To: D. Davies, WECC
D. Tucker, WECC
E. Davies, WECC
K. Bolton, WECC
From: J. Undrill
Date: 27 November 2011
Re: Evaluation of conversion of excitation system models in the WECC data base

The conversion of WECC excitation system models, as contained in dynamics data file 12hs31s.dyd has revealed a number of instances where the parameter values presently in use are open to question. This memo notes the instances that have been found and describes corrections/adjustments that have been made in the course of converting older, ex-series, excitation models into the new IEEE es-series models.

Figure 1 BALZ 1 and 2 (without correction of vimax)

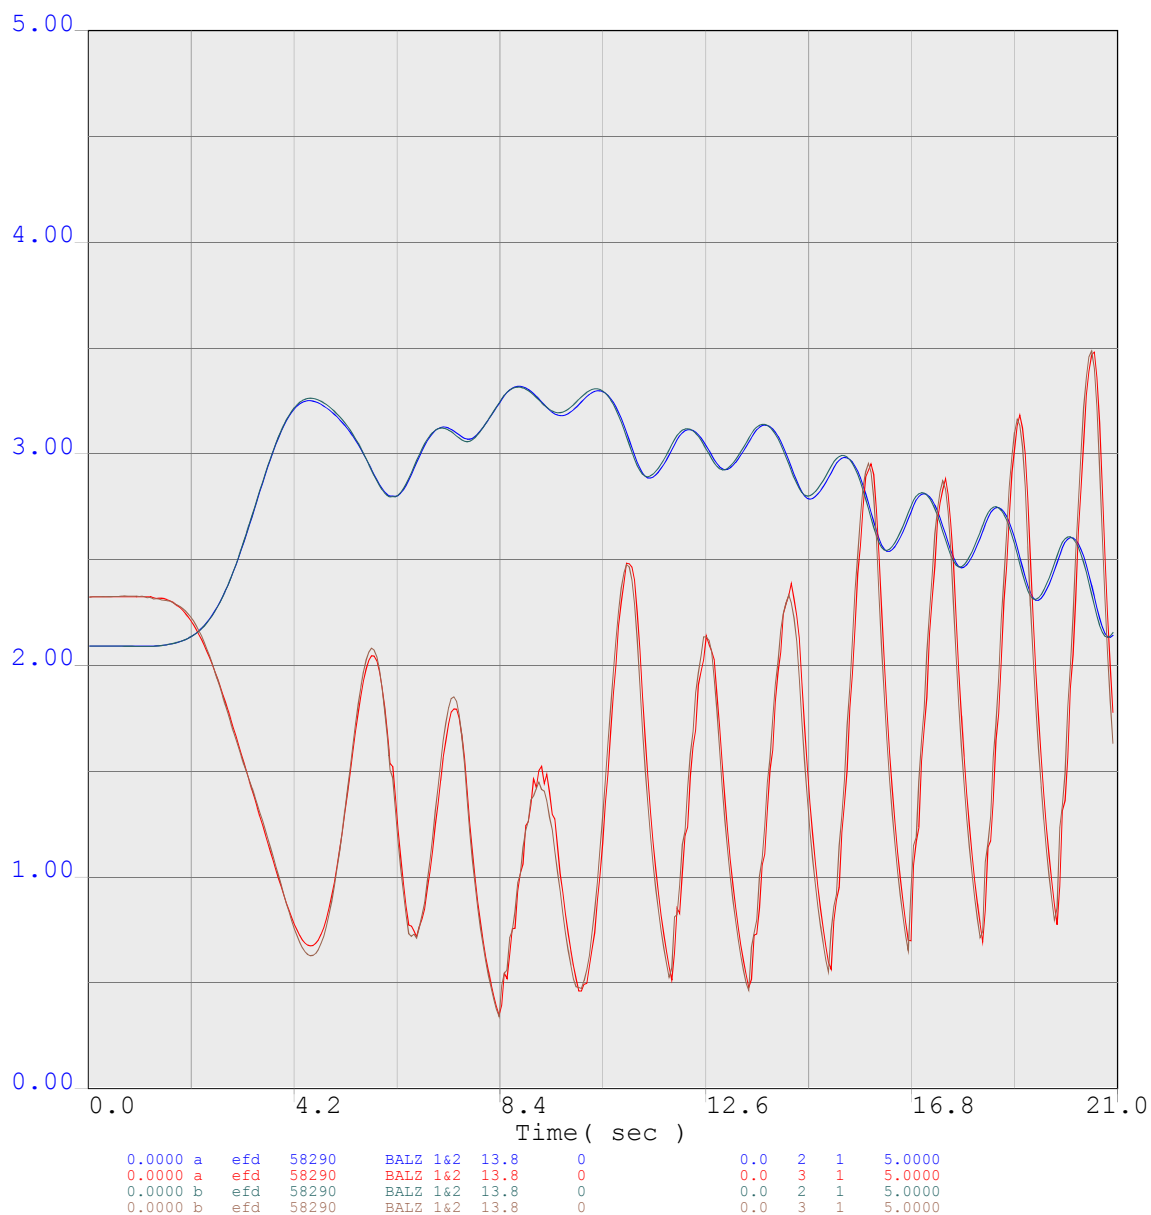
The value of vimin in the exac8b model of unit "3 " at this bus is zero. This value renders the exac8b model completely inactive. When exac8b is replaced by the esac8b model the excitation system becomes active because esac8b does not include the limit on the input signal. The response of BALZ is therefore different in simulations with the two models.

Figures 1 and 2 show the difference produced at Balz by correcting Vimin. Figure 1 was made with the exac8b model and original data (red, blue) and with the new esac8b model as produced by 3ic. There is no agreement because the original modeling allowed no change in the field voltage (red) of one of the two generators. Figure 2 shows the field voltage trajectories produced by the original exac8b modeling with Vimin corrected, and with the new modeling. The agreement between the original modeling and that produced by 3ic is now near-perfect.

Vimin was changed to 0.1 in the working file 12hs31j.dyd.

Figure 3 Behavior of HaynesG5
 AVR step response - on line
 Lower Original exst4b with PSS on
 Middle Replaced esst4b with PSS on
 Upper Original and Replaced respond differently (but are identical)

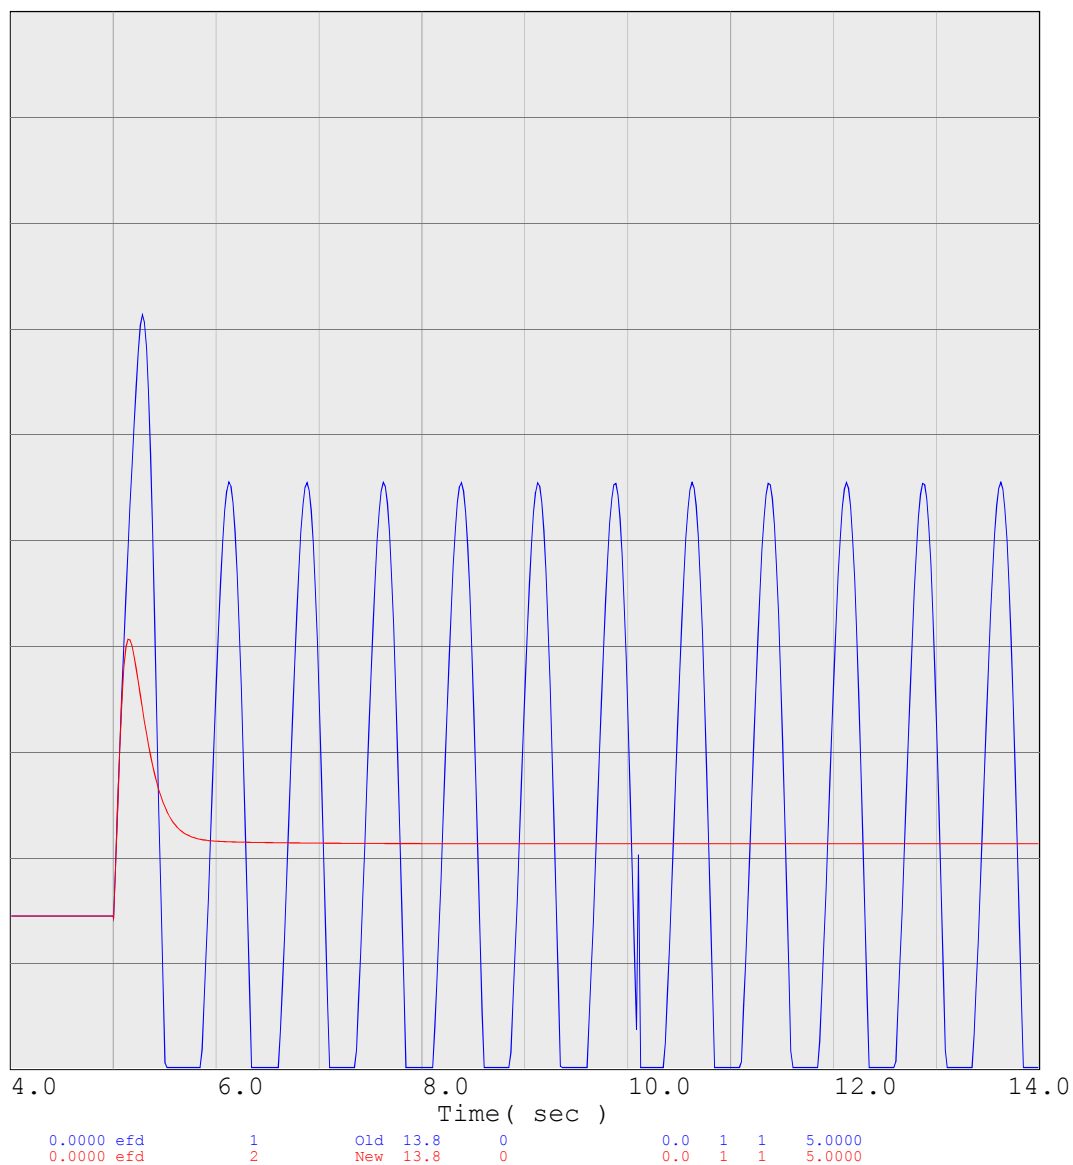
Simulations made with the exst4b model of the original file show a high frequency oscillation that is only marginally damped stable. Simulations made with the replacement esst1 model show the same high frequency oscillation but in this case it is marginally unstable. The implementations of the simulation in exst4b and esst4b are slightly different and this explains the difference in the stability of the high frequency oscillation.

Checking the HAYNES5G modeling for that machine, using 4ia and cc.p, shows good behavior with both exst4b and esst4b. It is apparent, therefore, that the unstable high frequency oscillation seen in full system simulations is associated with local conditions other than the excitation system.

- (lower) as modeled in the original data file with the exst4b model and stabilizers on on the HP and LP generators
- (mid) as modeled by the esst4b models produced by 3ic with stabilizers on on both generators
- (upper) as modeled by the esst4b models produced by 3ic with stabilizers off on both generators

Turning off the pss2a power system stabilizer models on HAYNES5G results in matching results with the two excitation system models in full-WECC cases.

The pss2a models were turned off in the working file 12hs31j.dyd.

Figure 4 Kyrene 4
Open circuit response

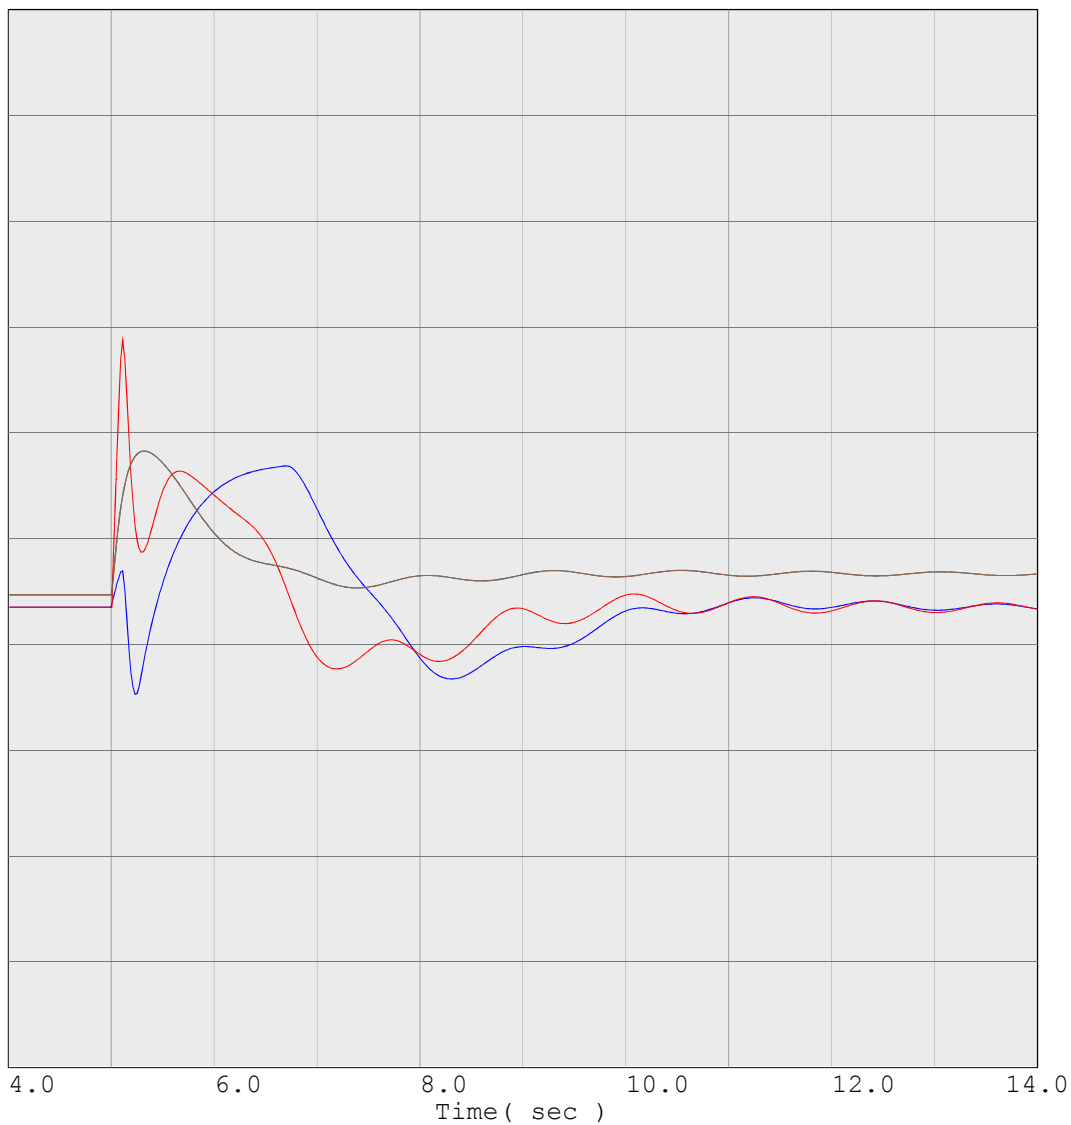
The value of the rate feedback gain, K_f , is 0.0 in the original data file. Because the forward gain of the voltage regulator (K_a) is 400 and the forward-path lead-lag block is unused, the transient gain of the system is excessive and check simulations made with both exac1 and esac1a in the b.p program show unacceptable response.

Figure 4 shows the open circuit behavior of the machine with the original exac1 model and data (blue) and with the esac1a modeling produced by 3ia with the correction of the rate feedback gain, K_f .

The exac1-esac1a MCDF has been updated to ensure that $K_f \geq 0.02$ if the forward lead-lag element does not provide a reduction in transient gain.
